STAFF REPORT
(One-Step Final Plat)

CASE NUMBER: SUB 2005-51 -- BLUE SKY ADDITION

CASE NUMBER: SUB 2005-51 -- BLUE SKY ADDITION

STAFF REPORT
(One-Step Final Plat, Deferred 6/16/05)

VICINITY MAP

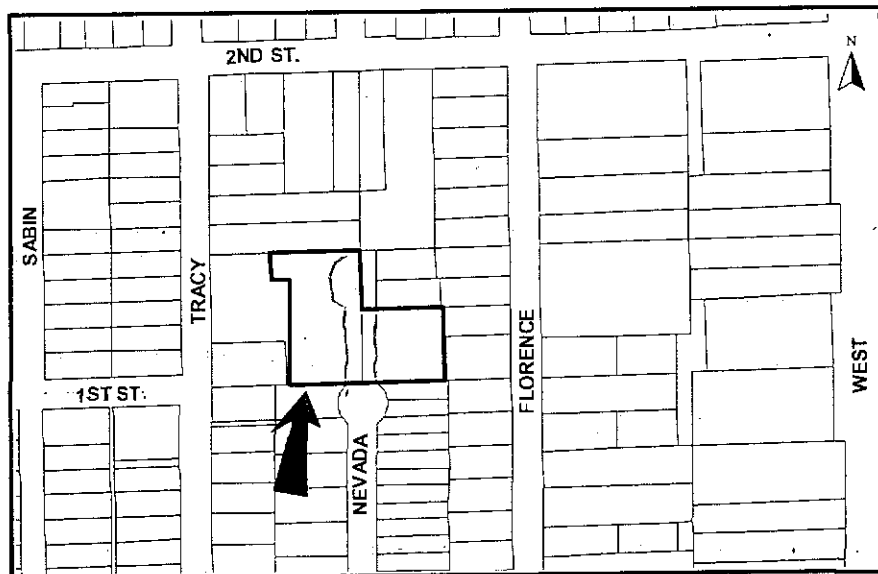
- H. The vicinity map indicates two sites.
- I. Reference to section, township and range needs added.
- J. The standard language regarding vacation statutes need to be referenced.

VICINITY MAP

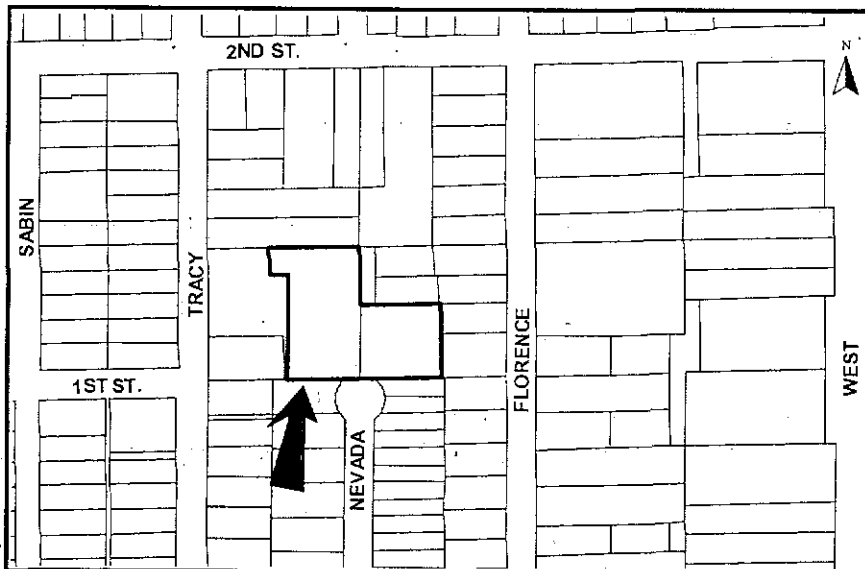
- E. The vicinity map indicates two sites.
- F. The standard language regarding vacation statutes need to be referenced.
- G. County Surveying advises that in the legal Description "LOTS 8 AND 9, 270.47 FEET" needs changed to "LOTS 8 AND 10, 270.47 FEET".

VICINITY MAP

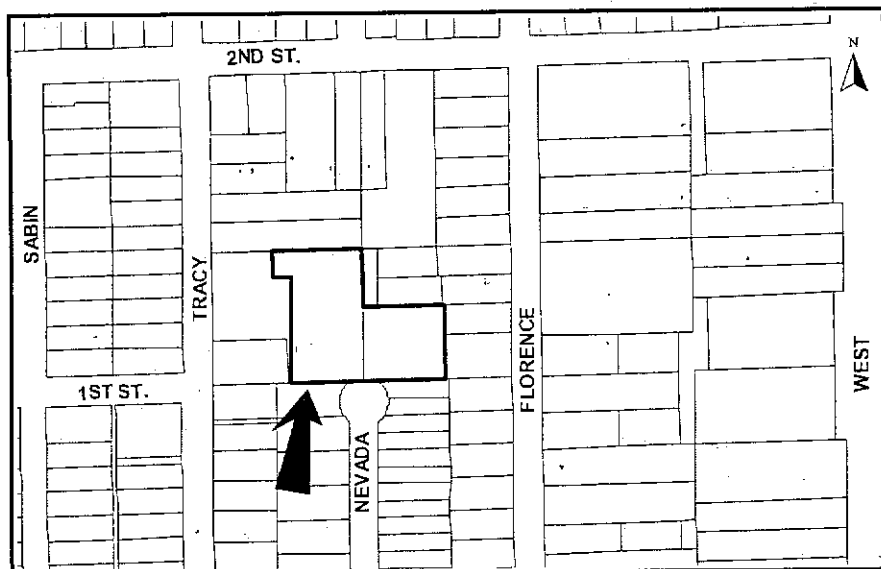
- J. The vicinity map indicates two sites.
- K. County Surveying advises that in the legal Description "LOTS 8 AND 9, 270.47 FEET" needs changed to "LOTS 8 AND 10, 270.47 FEET".
